**Town of Gorham  
 Planning Board Meeting  
 January 8, 2024**

**Item 4 - Public Hearing – Site Plan - Novel Energy Solutions – Dyer Road Solar Facility** – a request for approval to construct a 700 kW community solar array and associated infrastructure. Map 69, Lot 1-1. Zoned UREXP. The applicant is self-represented.

**TOWN OF GORHAM PLANNING BOARD**  
**FINDINGS OF FACT**  
**For**  
**NOVEL ENERGY SOLUTIONS – DYER ROAD SOLAR PROJECT, SITE PLAN**

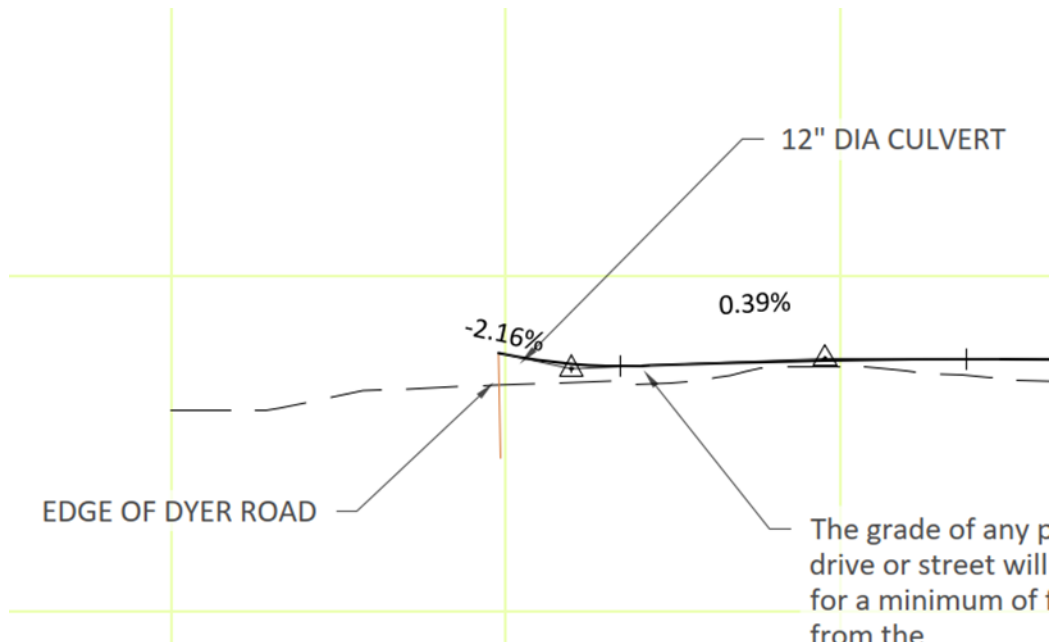
**WP Follow-up Response: The Erosion Control Plan shows silt fence around the solar array and westerly (upgradient) side of the access road, but not on the easterly**

(downgradient) side of the access road. Silt fence should be proposed on the easterly side of the access road to prevent sediment track out on the access road from washing off site, out of the easement area, and to the adjacent wetland. A double row of silt fence is recommended within 75' of the wetland.
